**SAMPLING AND ANALYSIS PLAN  
ADDENDUM NO. 1**

**PHASE I REMEDIAL INVESTIGATION OF  
RAMSDELL QUARRY LANDFILL AT THE  
RAVENNA ARMY AMMUNITION PLANT,  
RAVENNA, OHIO**

**Comment Response Table**  
**Draft Phase I Remedial Investigation Sampling and Analysis Plan Addenda for Ramsdell Quarry**  
**at the Ravenna Army Ammunition Plant, Ravenna, Ohio**

Figure 4-1. Proposed Ramsdell Quarry Phase I RI Surface Soil Sampling and Groundwater Monitoring Well Locations

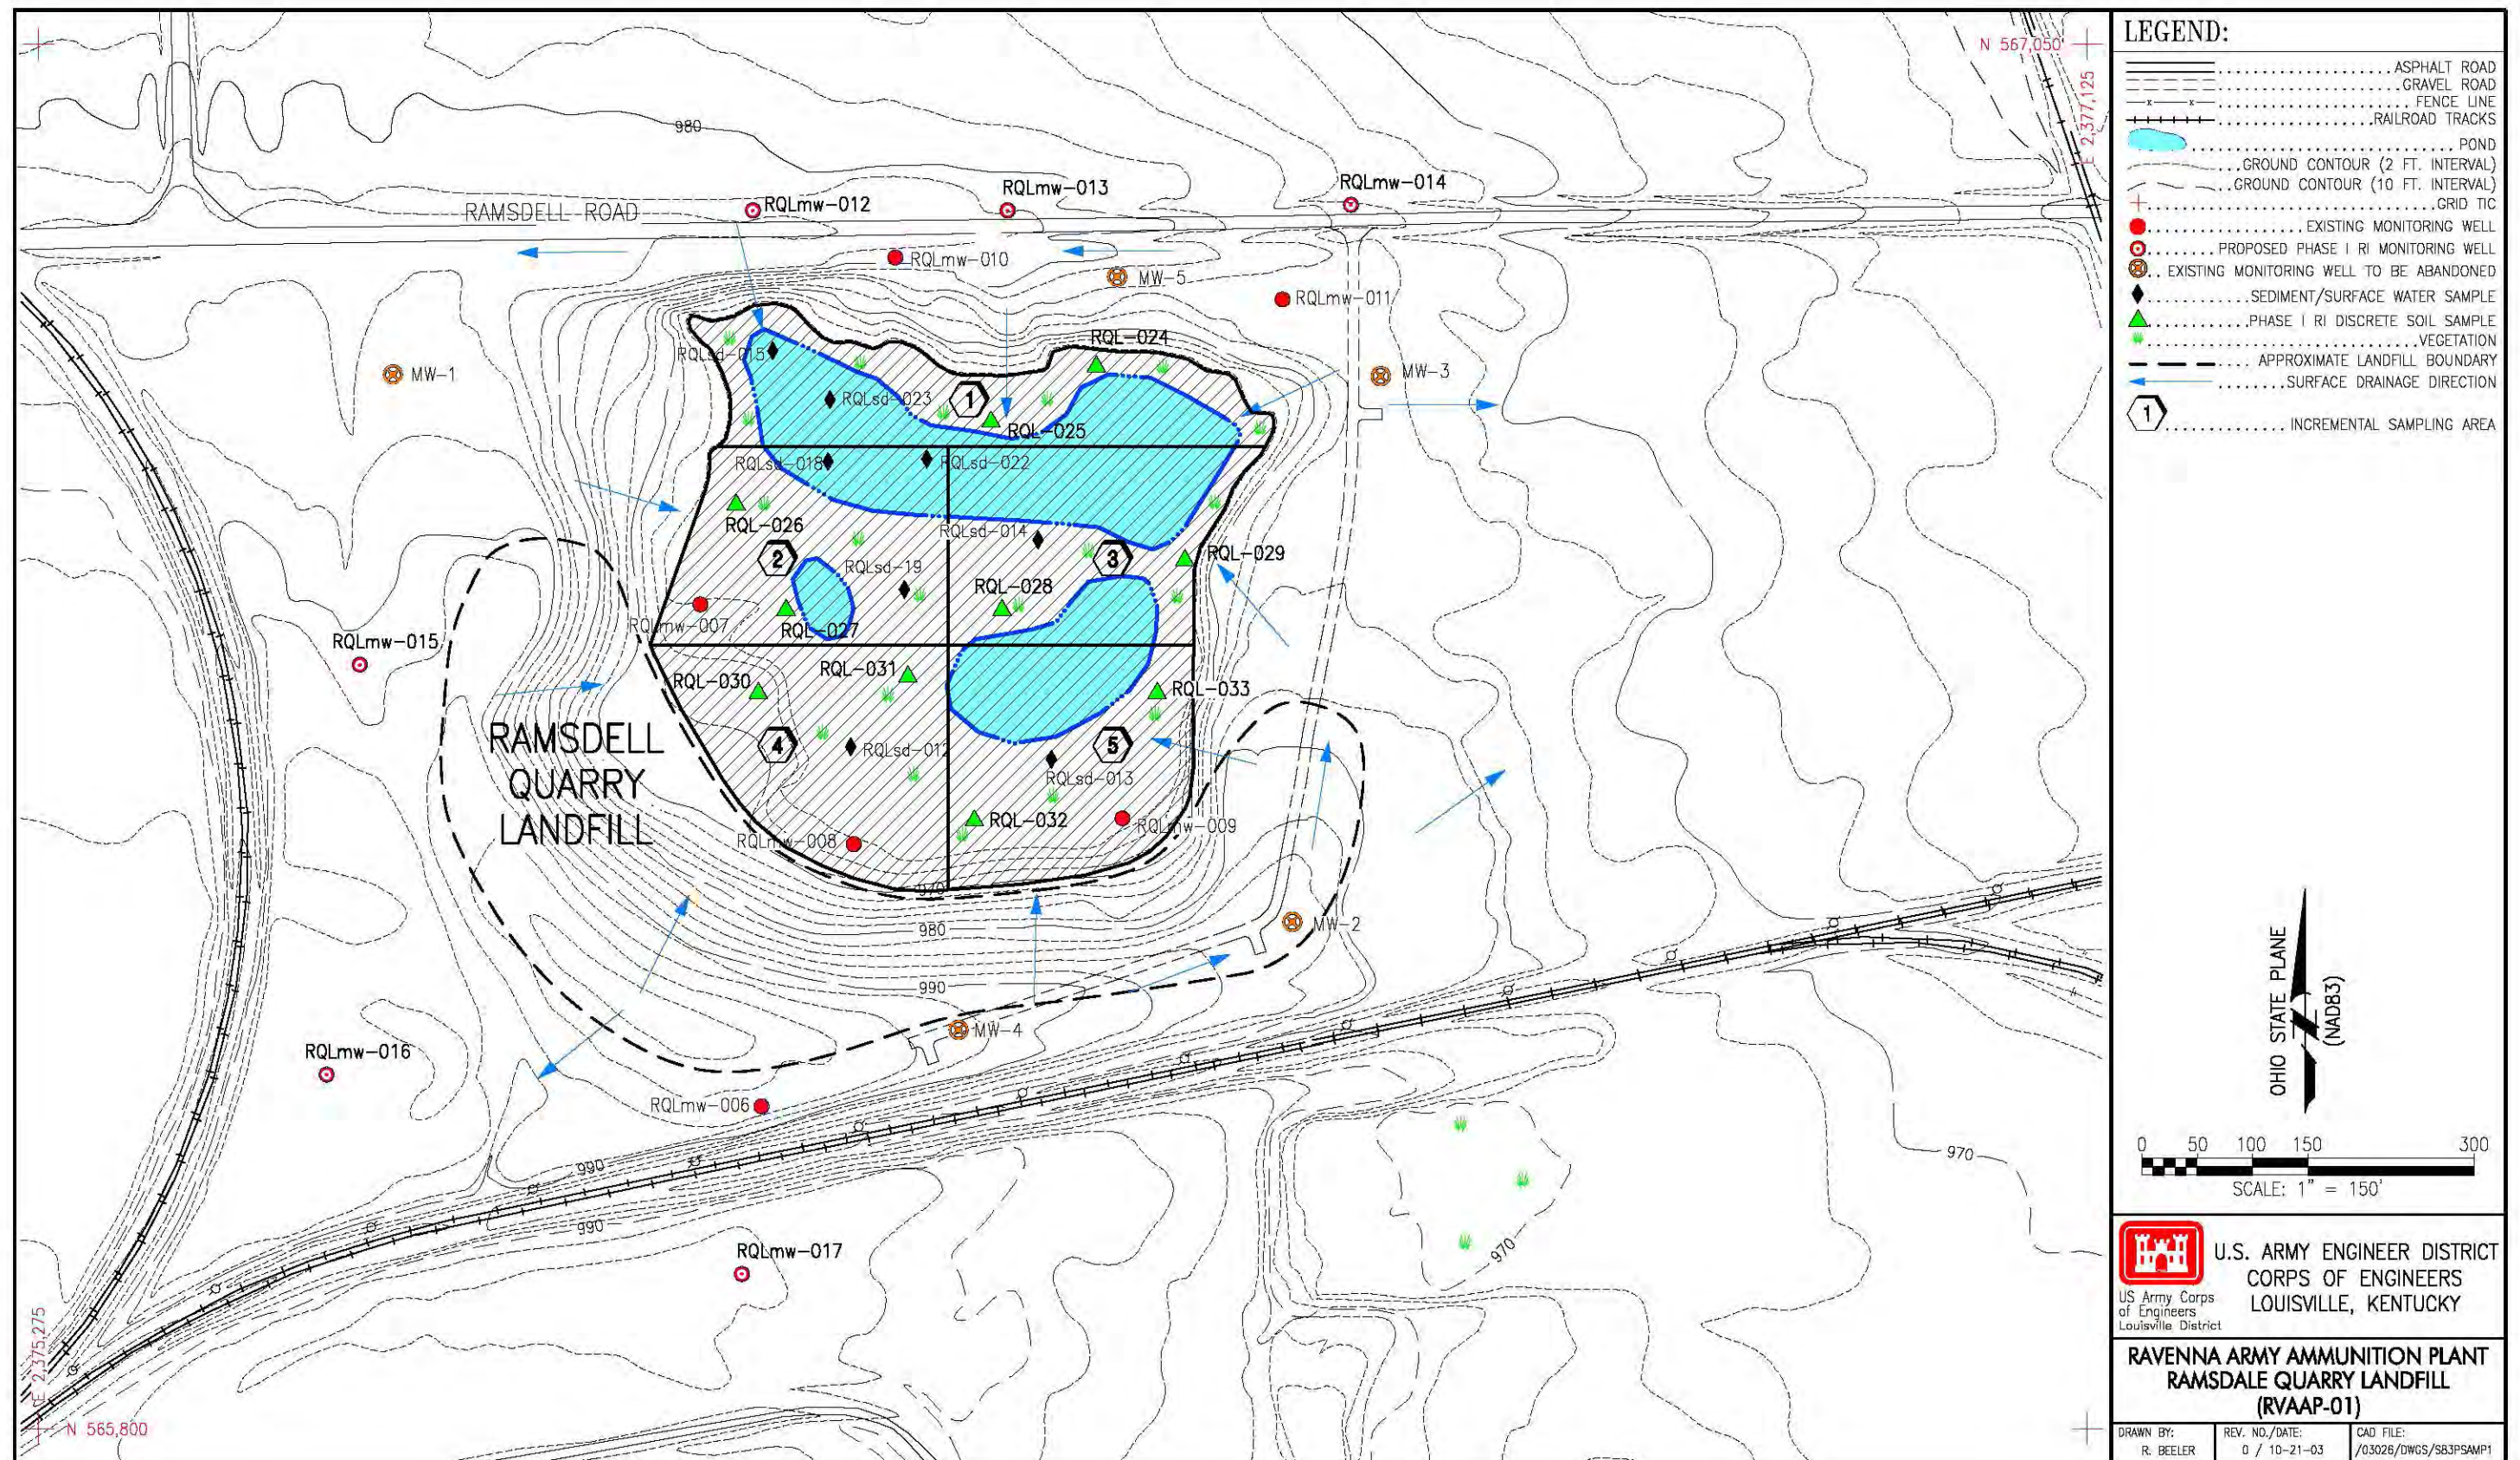
| Comment Number                                                                 | Page or Sheet                          | Comment                                                                                                                                                                                                                                                                                                                                                                                                                                                                                                                                                                                                                                                                                                                                                                                            | Response                                                                                                                                                                                                                                                                                                                                                                                                                                                                                                |
|--------------------------------------------------------------------------------|----------------------------------------|----------------------------------------------------------------------------------------------------------------------------------------------------------------------------------------------------------------------------------------------------------------------------------------------------------------------------------------------------------------------------------------------------------------------------------------------------------------------------------------------------------------------------------------------------------------------------------------------------------------------------------------------------------------------------------------------------------------------------------------------------------------------------------------------------|---------------------------------------------------------------------------------------------------------------------------------------------------------------------------------------------------------------------------------------------------------------------------------------------------------------------------------------------------------------------------------------------------------------------------------------------------------------------------------------------------------|
| 7.                                                                             | Figure 4-1                             | Printing error, Add separate symbol for and designate the wells to be abandoned.                                                                                                                                                                                                                                                                                                                                                                                                                                                                                                                                                                                                                                                                                                                   | Agree. Figure has been corrected.                                                                                                                                                                                                                                                                                                                                                                                                                                                                       |
